TECHNICAL BULLETIN

Heating Systems	September 20, 2007	Bulletin Identification No.: MTB-103-11
Release Type: Public

Affected Model(s): OASIS CH50, H2, H2L, and HWH

Description: Fuel return restrictor

Figure 1: 0.07" Orifice

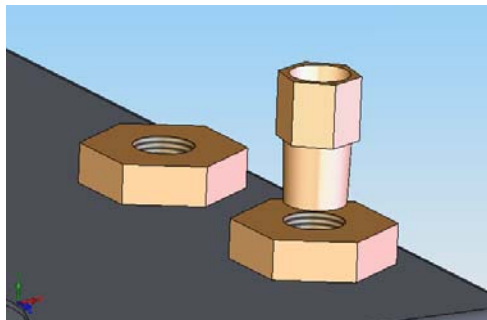
If heaters prior to the above serial numbers are experiencing frequent flame faults and/or making popping sounds, add a restrictor (#2333, 0.07" orifice) to the fuel return line in order to create a positive fuel pressure on the regulator assuring a constant supply of fuel to the nozzle. The restrictor can, as show in the example below, be placed anywhere in the fuel return line close to the heater.
